Z-34
(2015)

BARRETT PARKWAY TRACT
COBB COUNTY, GEORGIA - LAND LOTS 291 & 318, 20th DISTRICT, 2nd SECTION
MARIETTA, GEORGIA

ZONING
PLAN

ZONING COMMENTS: Staff Member Responsible: Jason A. Campbell

| SHEET | Z-1 |

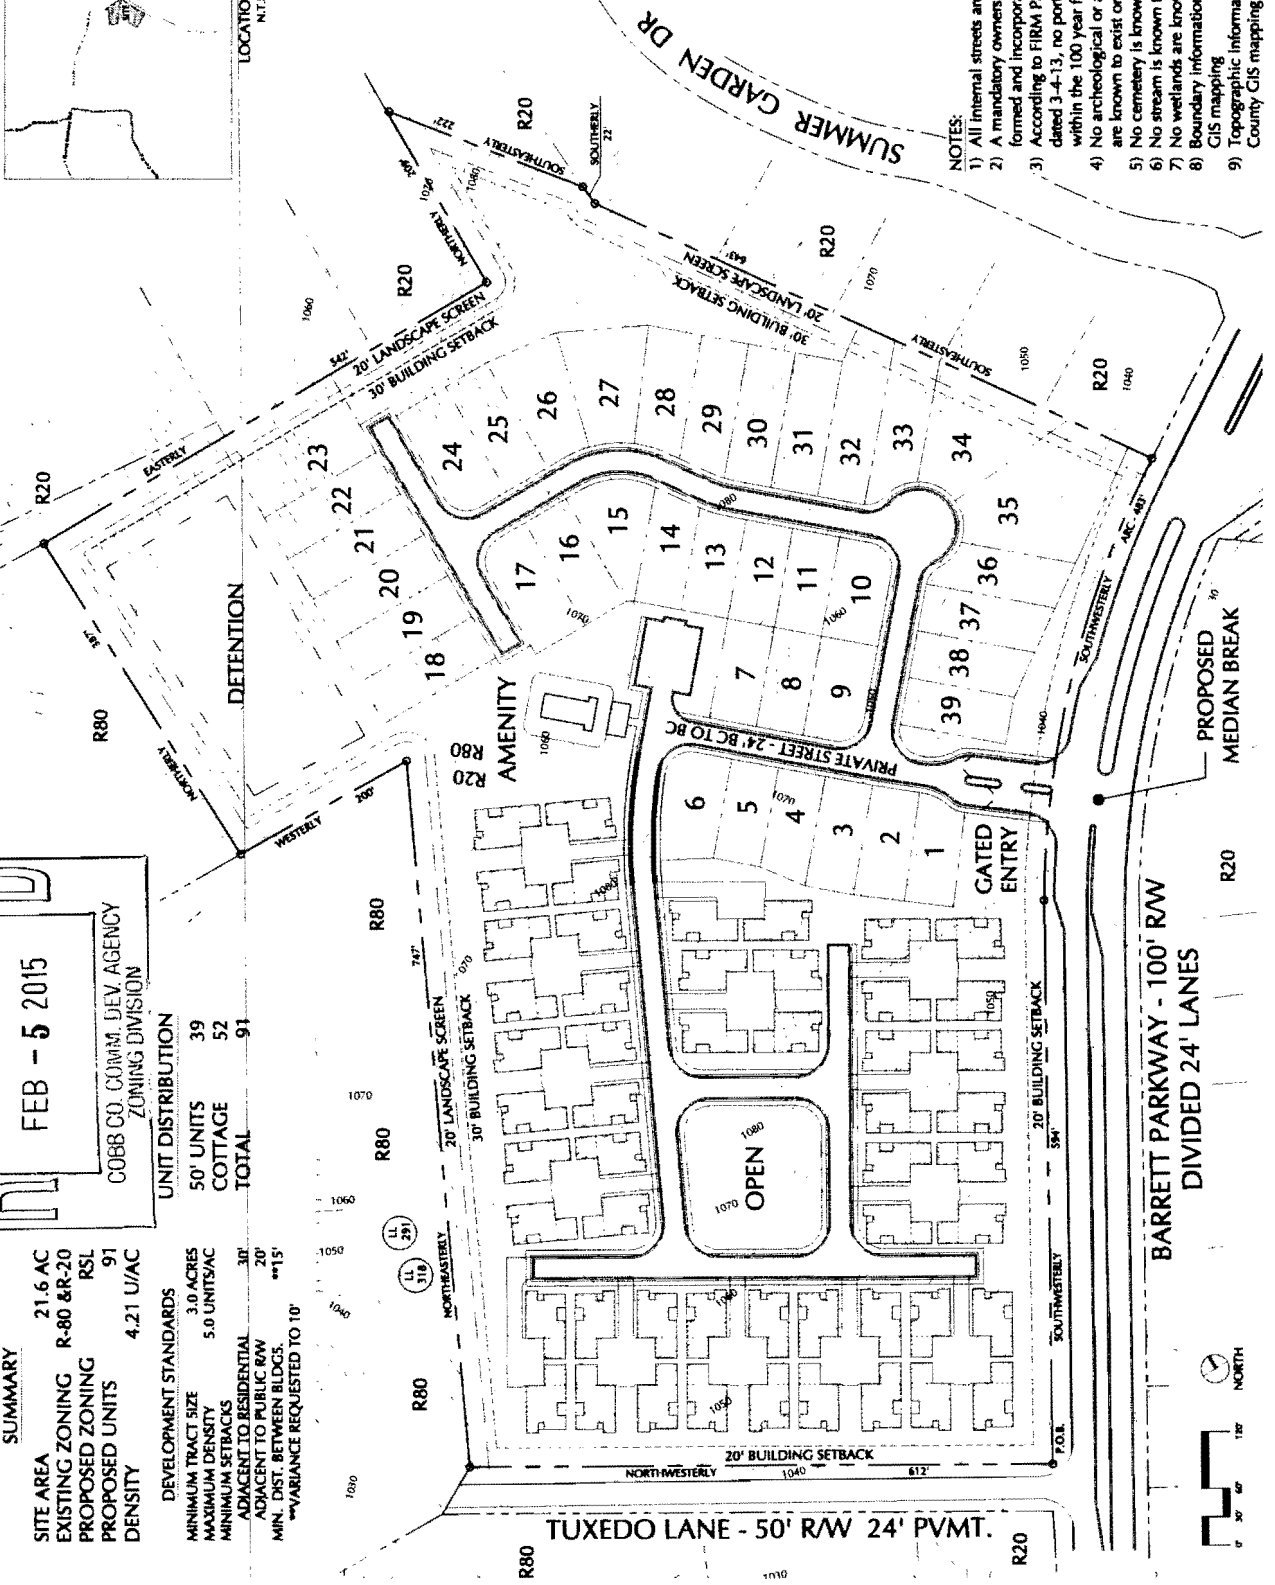
- Provide comprehensive hydrology/stormwater controls to include development of out parcels.
- Submit all proposed site improvements to Plan Review.
- Any **spring activity** uncovered must be addressed by a qualified geotechnical engineer (PE).
- Structural fill _____ must be placed under the direction of a qualified registered Georgia geotechnical engineer (PE).
- Existing facility.
- Project must comply with the Water Quality requirements of the CWA-NPDES-NPS Permit and County Water Quality Ordinance.
- Water Quality/Quantity contributions of the existing lake/pond on site must be continued as baseline conditions into proposed project.
- Calculate and provide % impervious of project site.
- Revisit design; reduce pavement area to reduce runoff and pollution.

- No Stormwater controls shown
- Copy of survey is not current – Additional comments may be forthcoming when current site conditions are exposed.
- No site improvements showing on exhibit.

1. This site is dominated by two knolls that create a ridgetline running roughly parallel to Barrett Parkway. The parcel is predominately wooded with slopes ranging from ~5 to 20%. The topography of the site is such that it drains in three separate directions – 41% to the east across Barrett Parkway, 22% to the south across Tuxedo Drive and 37% to the northwest.

2. Due to large drainage area splits of the onsite basins it is likely that an additional stormwater management facility will be required at or near the entrance and possible at the southeast corner of the site as well. This will most certainly impact the site layout and number of units.

3. Although there is an small existing cross drain under Tuxedo Drive, there is no well-defined conveyance downstream through the existing residential parcels. This issue will need to be addressed in Plan Review.

4. As indicated in the Downstream Conditions comments, there are two existing private lakes located downstream from this site. Additional BMP's for erosion sediment controls will be required as well as pre- and post-development sediment studies.

Recommend deceleration lane for the Ernest Barrett Parkway access.

Recommend right-in/right-out only for the Ernest Barrett Parkway access.

Recommend no new median break on Ernest Barrett Parkway.

Recommend sidewalks on, at least, one side of the street within subdivision.

- Maximum density of 2.5 units per acre;
- Site plan to be approved by the District Commissioner;
- Water and Sewer Division comments and recommendations;
- Stormwater Management Division comments and recommendations; and
- Department of Transportation comments and recommendations.
